Taunton, MA
Wastewater Treatment Facility
Phase I Improvements
CWSRF 4605
Addendum No. 3
July 30, 2021

This Addendum No. 3 forms a part of the Contract Documents and modifies the Bidding Documents dated July 2nd, 2021 as noted below. Acknowledge receipt of this Addendum in the space provided in the Bid Form. Failure to do so may subject the Bidder to disqualification.

SHEET NO.	S-2.1
-----------	-------

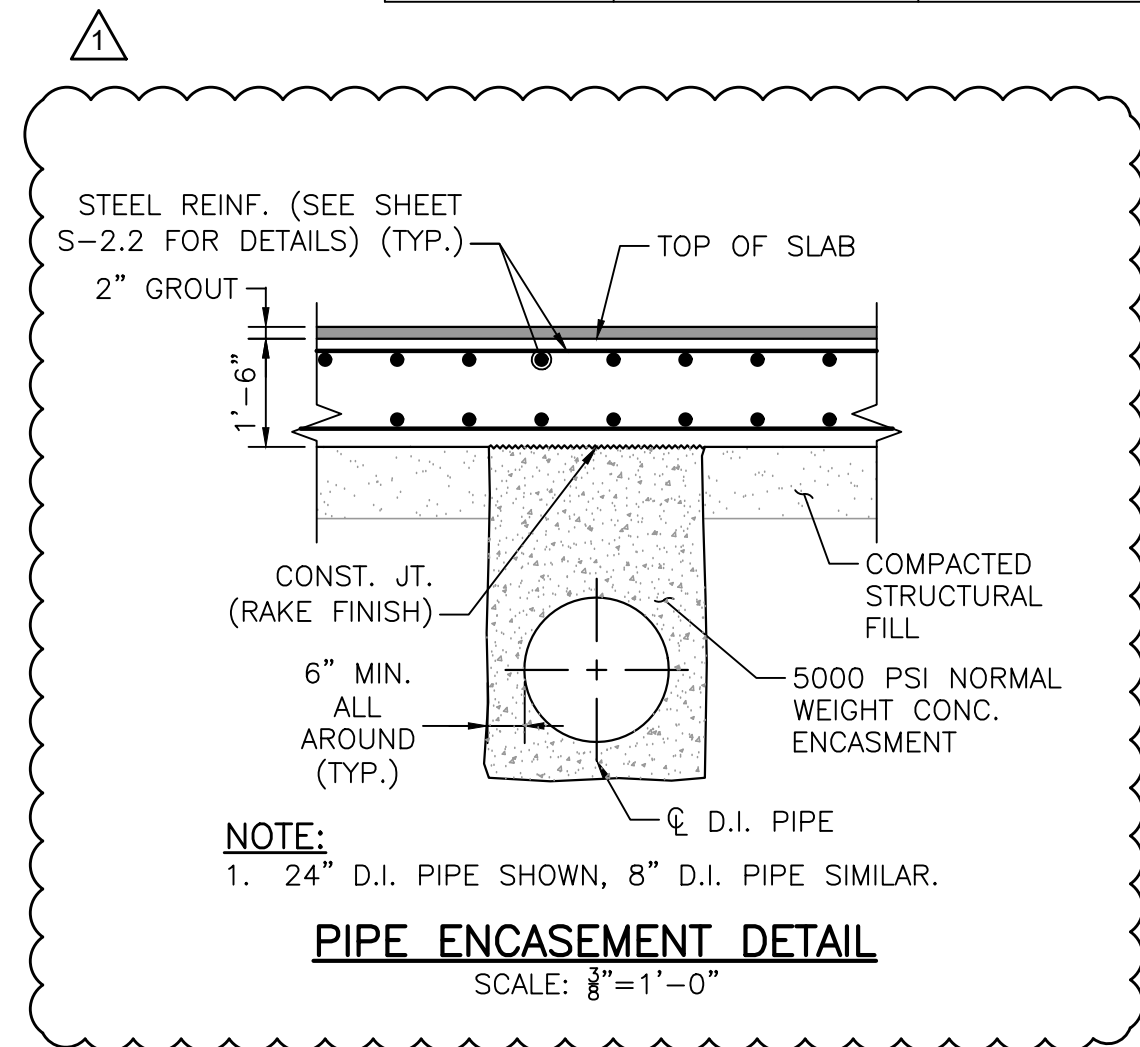
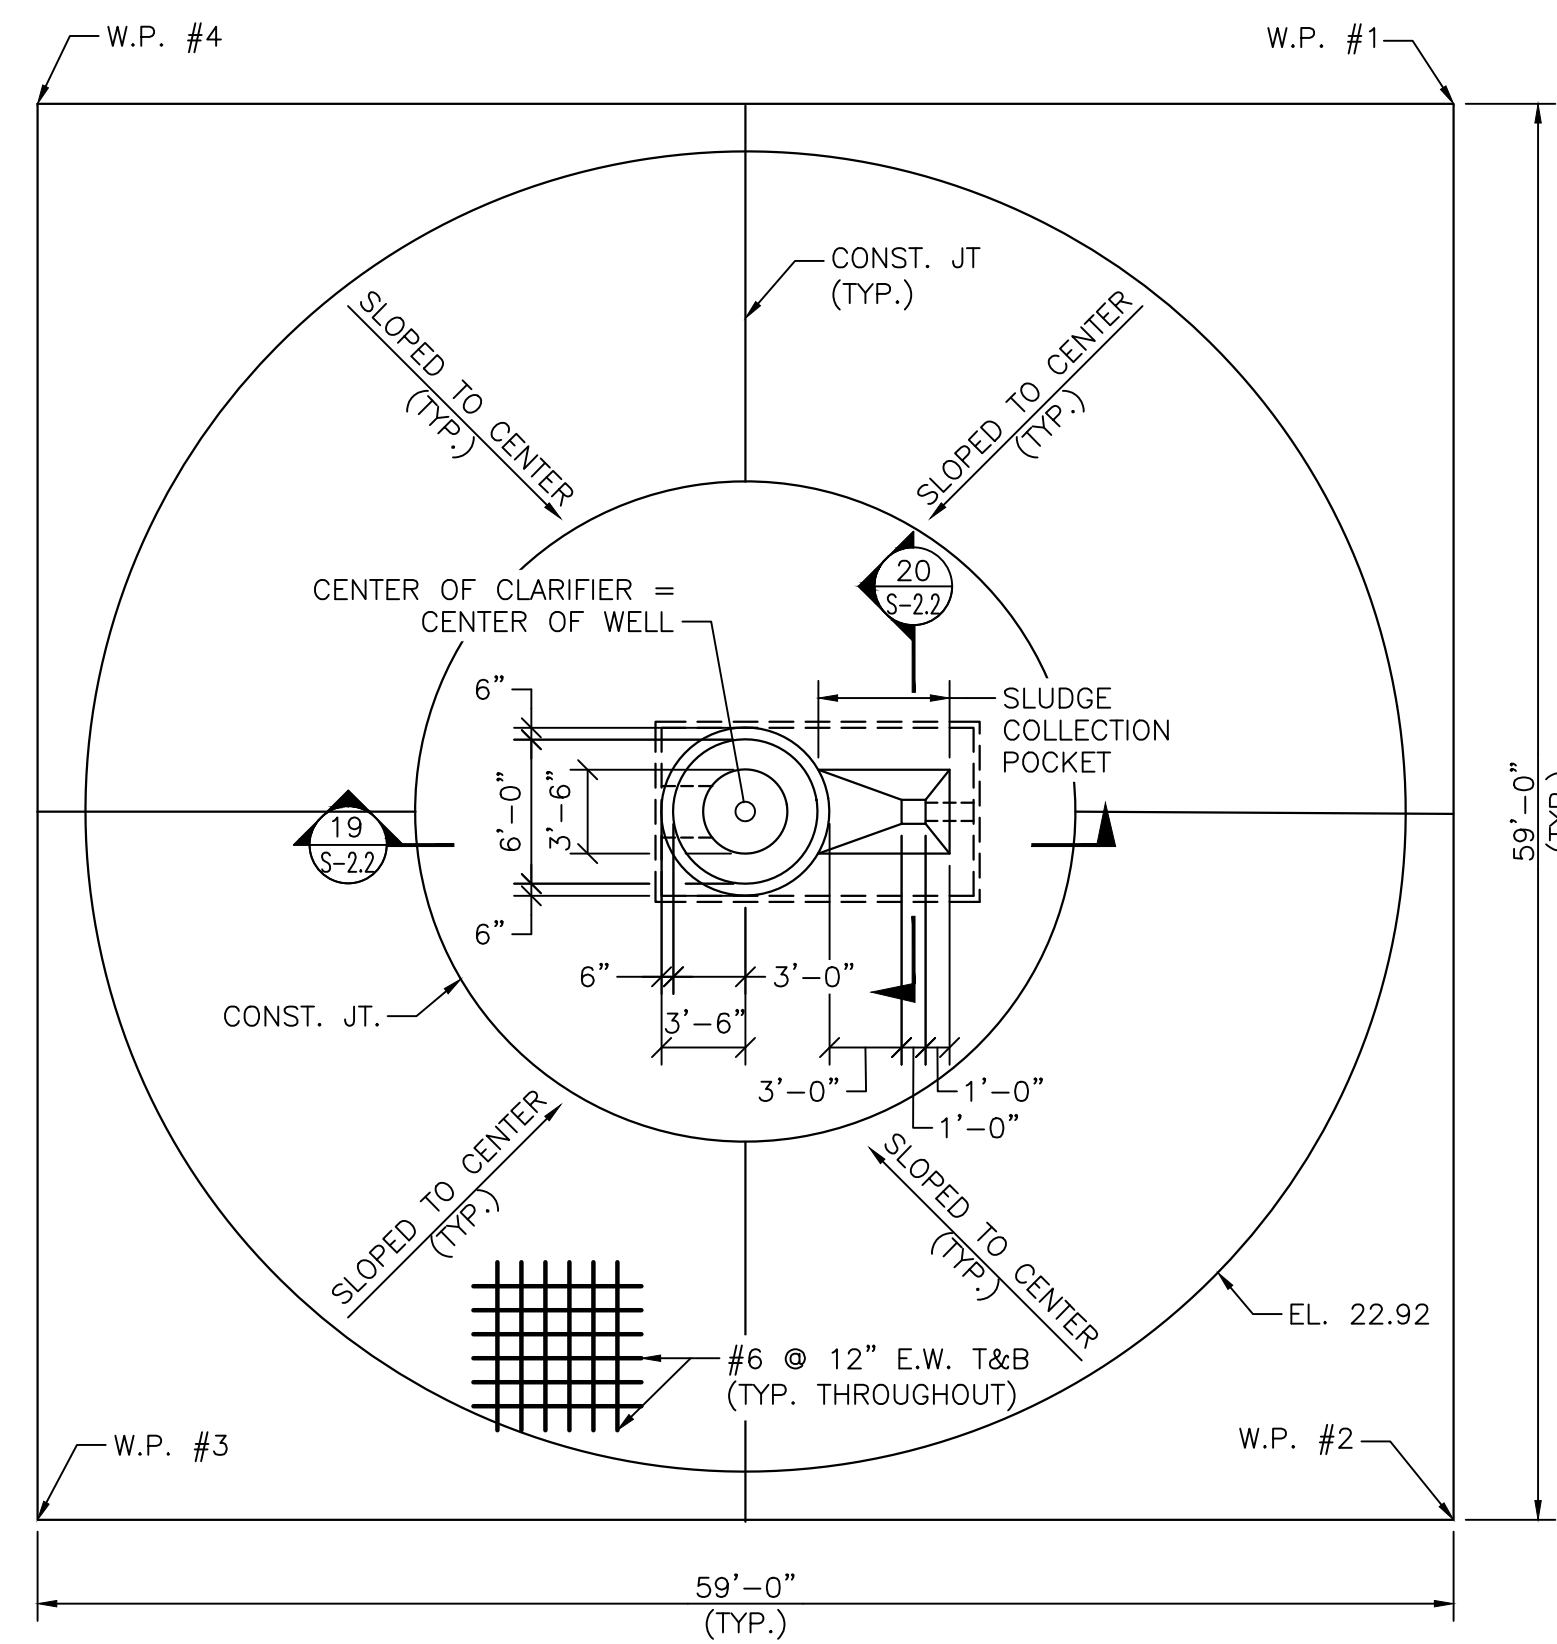
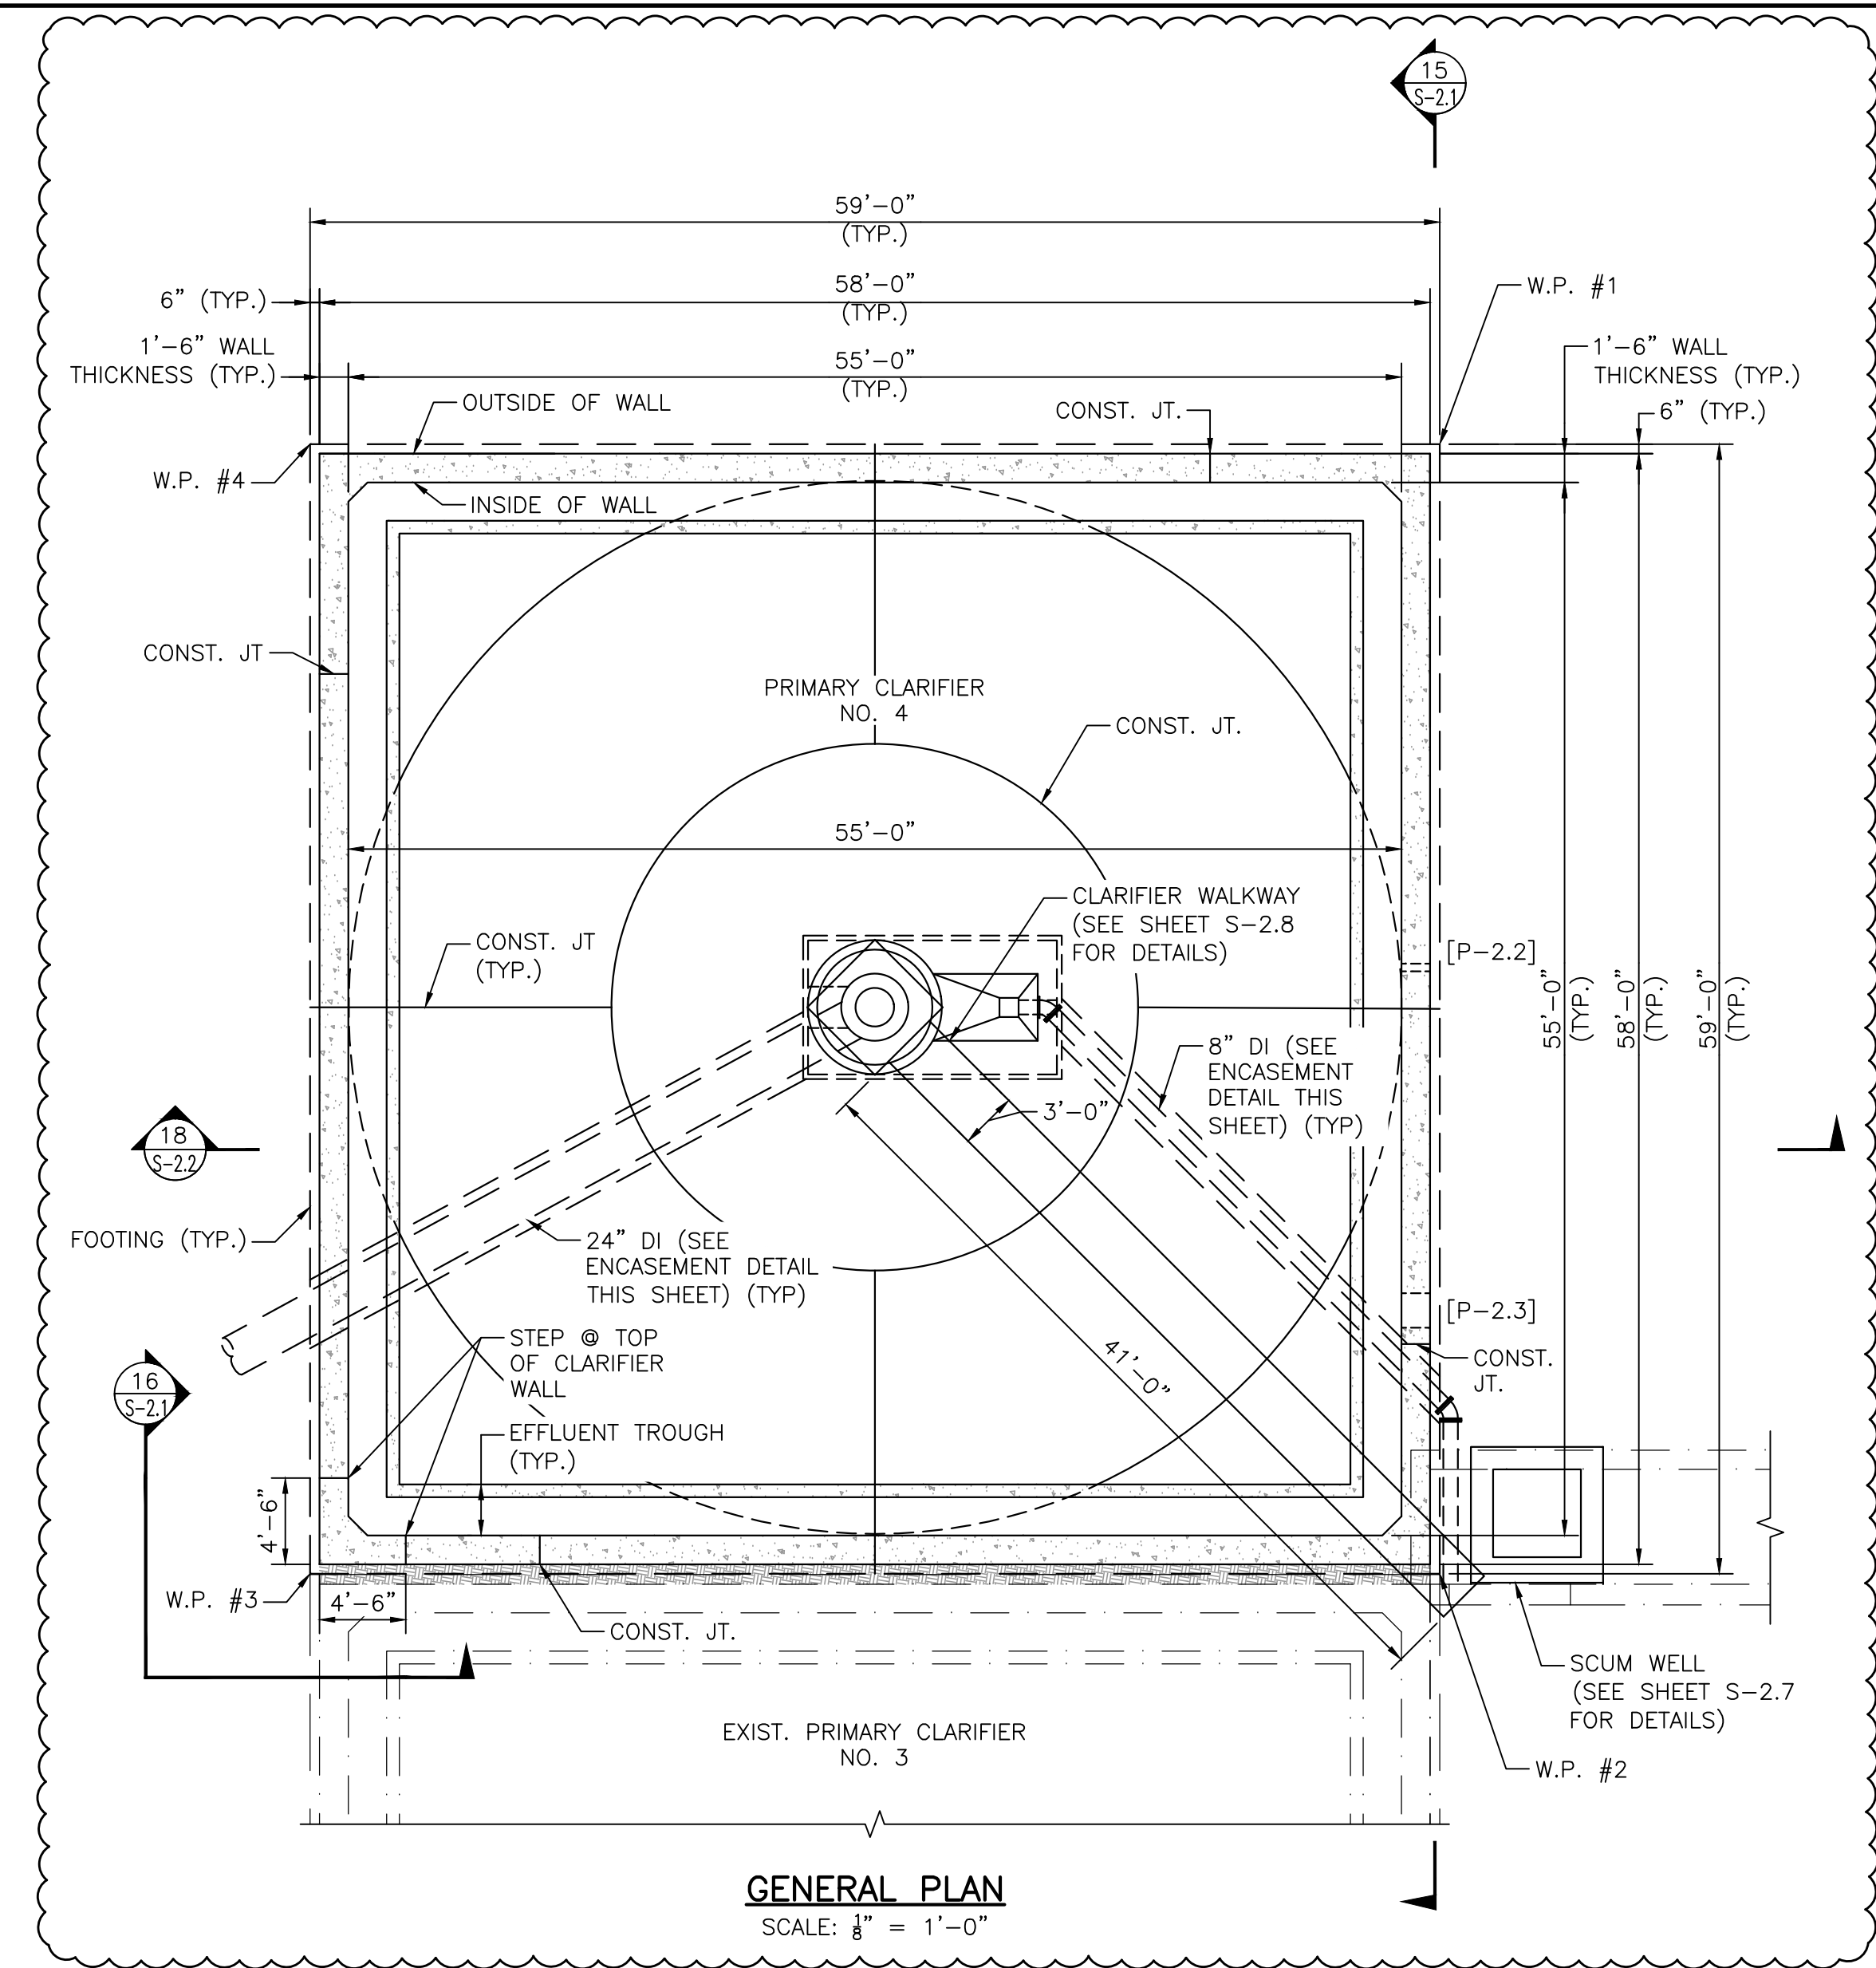
DELETE Primary Clarifier Plans and Elevations S-2.1 and **ADD** the attached Primary Clarifier Plans and Elevations S-2.1 Re-Issued Per Addendum
